LYNN WATER AND SEWER COMMISSION
400 PARKLAND AVE
LYNN, MASSACHUSETTS

BID #22-002
PHASE 3 WEST LYNN SEWER SEPARATION PROJECT NO. CWSRF-4488

CONTRACT DOCUMENTS
PART 2 - ADDENDUM NO. 6

INSERT Detail C-909B Double Grate Circular Catch Basin – Type 3

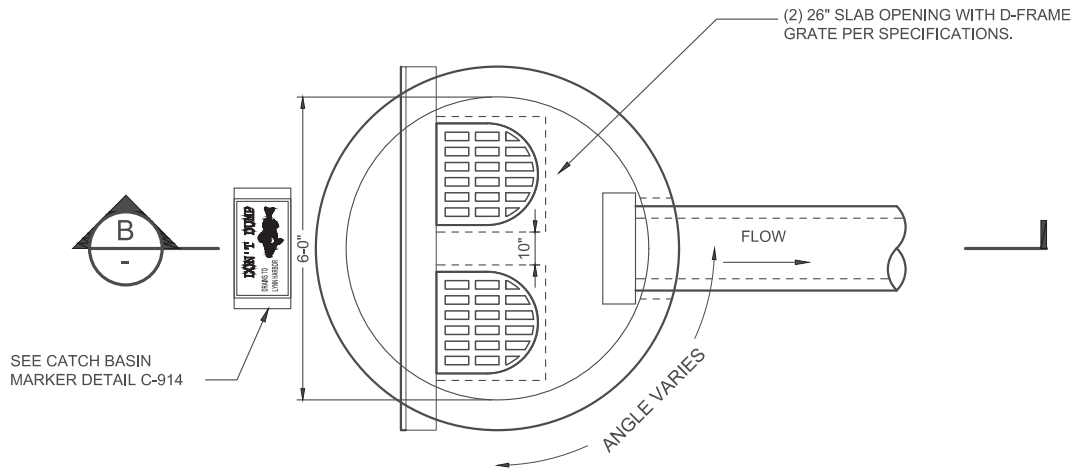
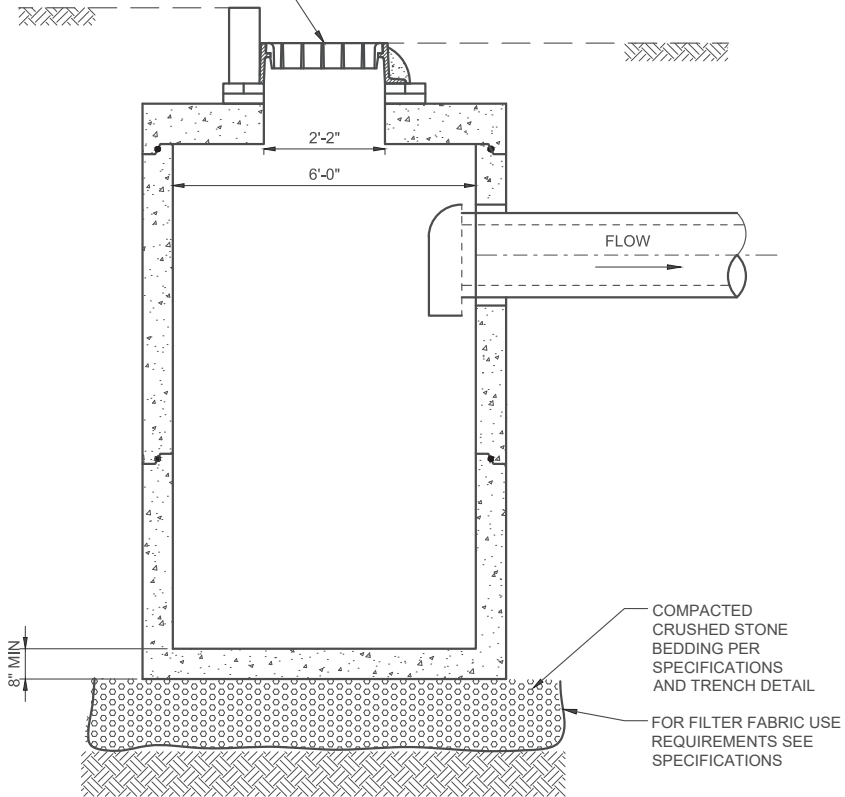
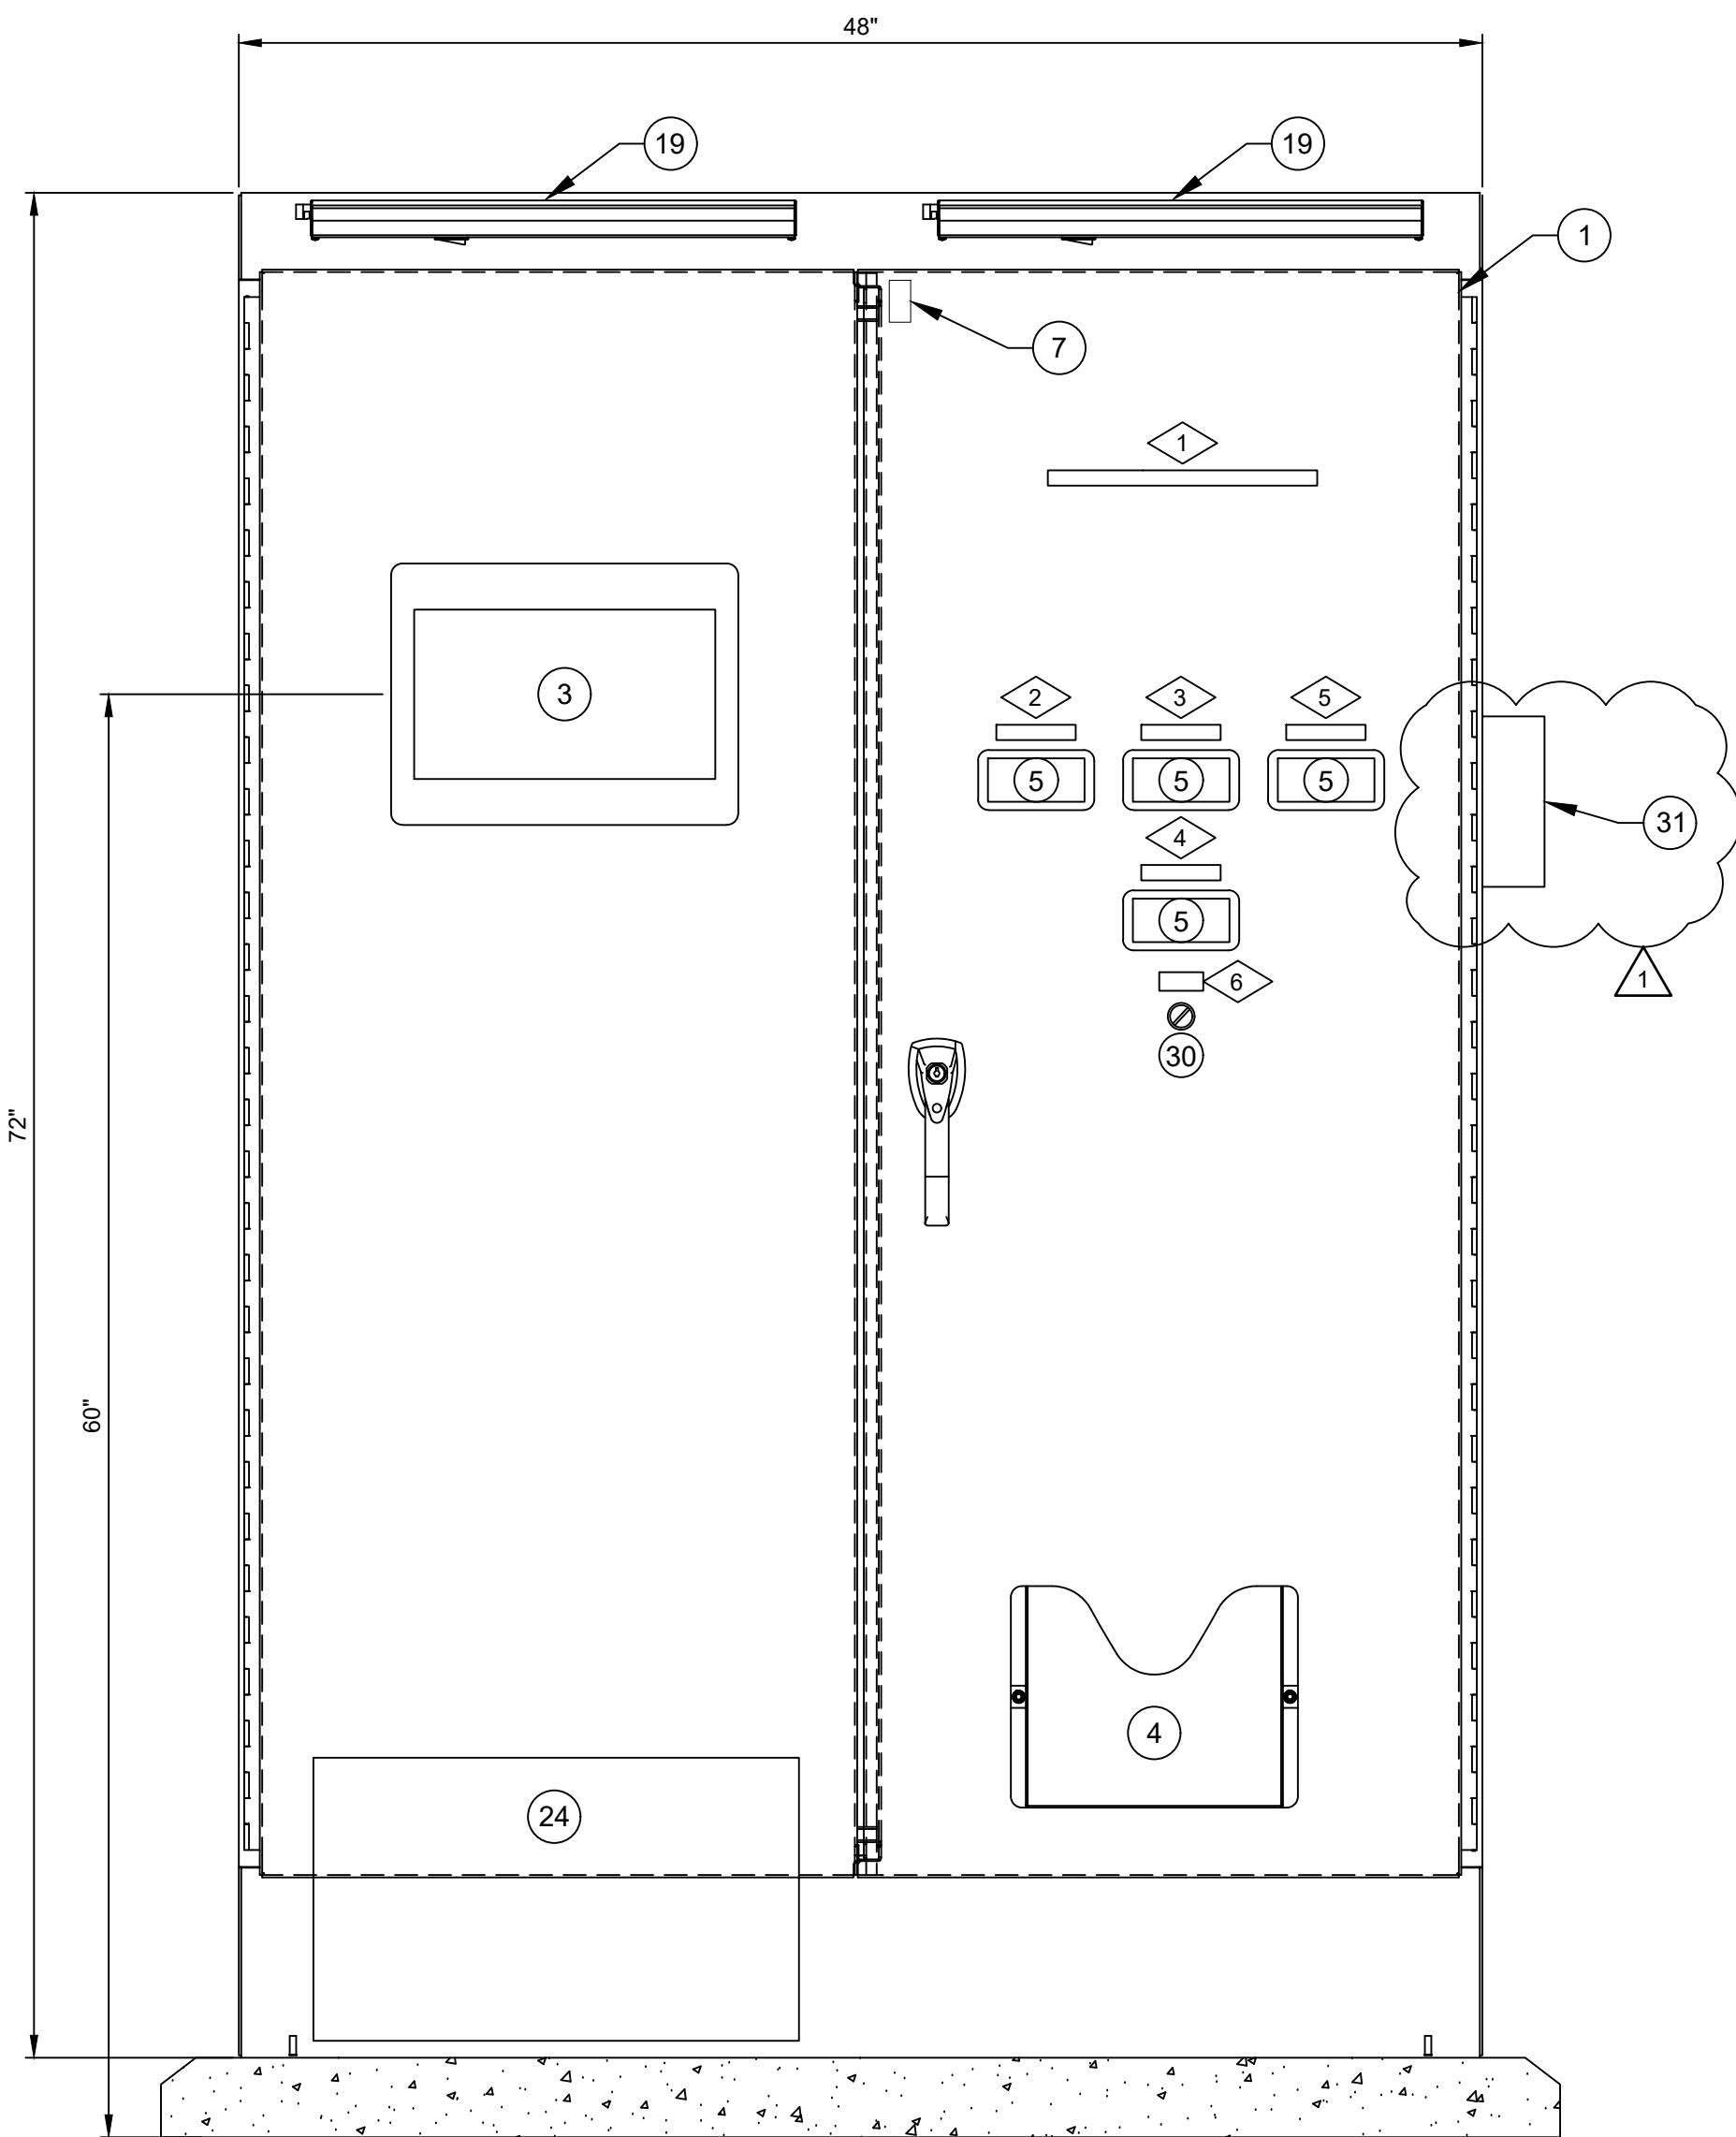
16. Drawing CG-06 Standard Details – Sheet 4 of 11
